Subject: RECALL R19AI – Service Brake Switch Bracket Deformation on Driver Control Module

IMPORTANT SAFETY RECALL NOTICE

NHTSA Recall Number: 19V-795 School Bus
NHTSA Recall Number: 19V-796 Non-School Bus

SUBJECT: RECALL R19AI – Service Brake Switch Bracket Deformation on Driver Control Module

Figure 1

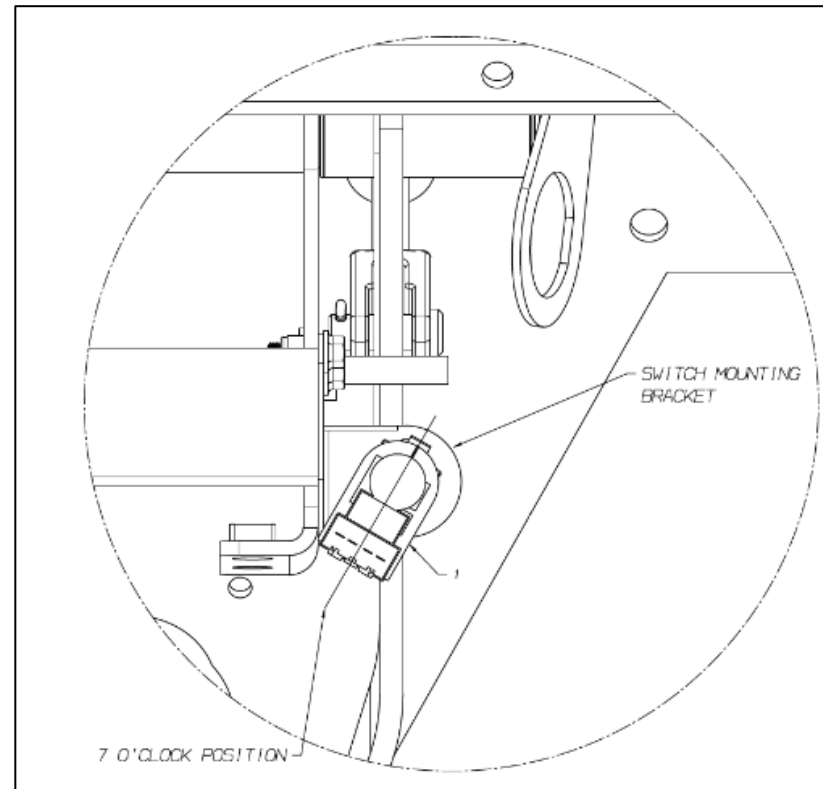
1. Locate service brake switch in front of driver's area, above brake pedal arm.
2. Disconnect the electrical connector from the service brake switch.
3. Rotate the service brake switch clockwise to the 7 o'clock position, and remove. (Figure 1)
The switch will not be reused, it should be marked as bad and discarded.

11. Remove C-clamp. Depress and release brake pedal, verify pedal returns and stops against rubber bumper without brake application.
12. **CAUTION-Ensure brake pedal remains in the normal, unapplied position for the next step.** Install the brake switch at the 7 o’clock position and rotate counterclockwise until it locks into place at the 6 o’clock position.

Figure 2

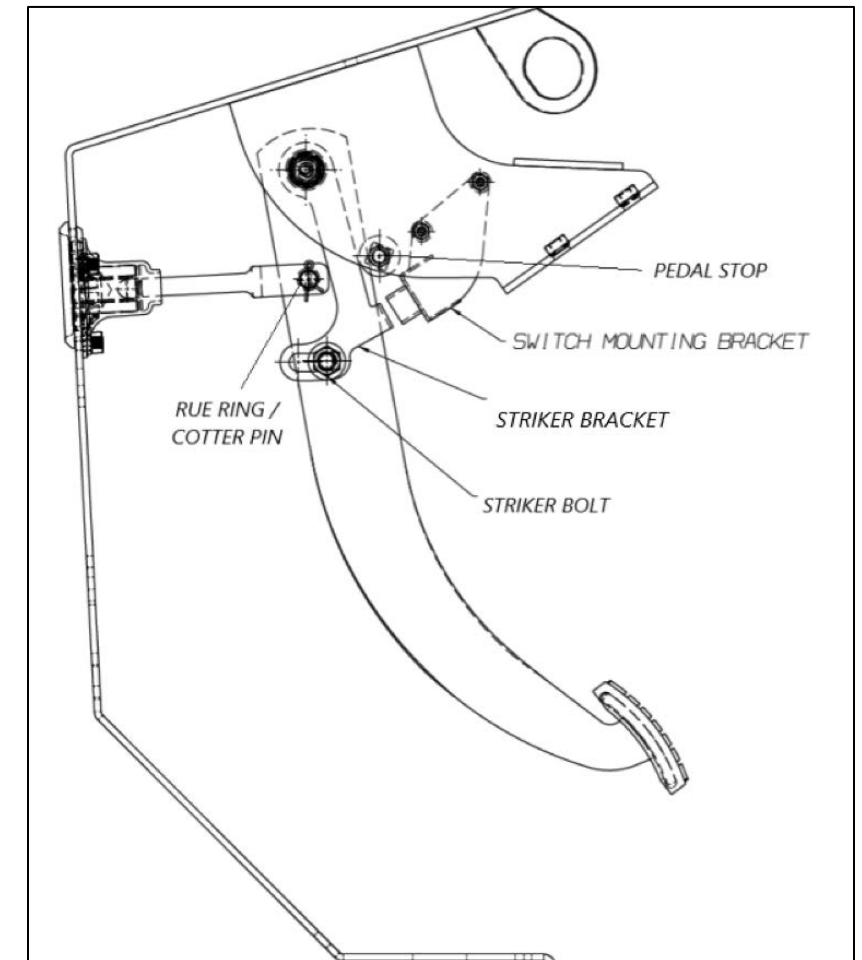
4. Remove the two fasteners mounting the switch mounting bracket to the steering column housing. Retain the mounting fasteners. *The switch bracket will not be reused, it should be discarded.* (Figure 2 and 3)

5. Remove and retain the E-Clip, nut and washer from brake pedal pivot shaft (Figure 3)
6. Remove the rue ring (or cotter key) and clevis pin from yoke/brake pedal (Figure 2)

7. If necessary, back off the pedal stop (threaded bolt) from steering column bracket to allow free motion of the brake pedal. (Figure 2)
8. Rotate brake pedal fore and aft, as necessary, while sliding to the right until removed from pivot shaft. (Figure 3)

Figure 3

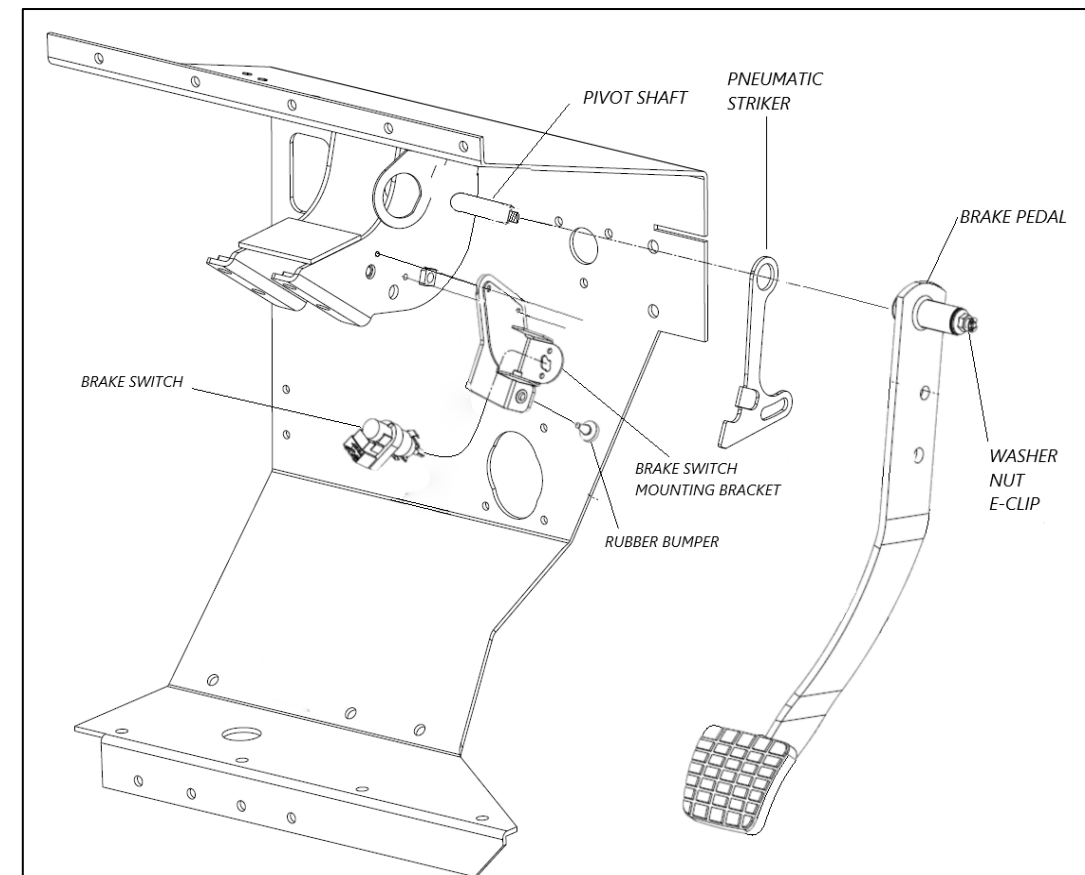
9. Remove striker bracket from brake pedal assembly. (Figure 3) Retain the 1/2" striker nut, bolt and washers, as they will be reused.
The striker bracket will not be reused, it should be discarded.
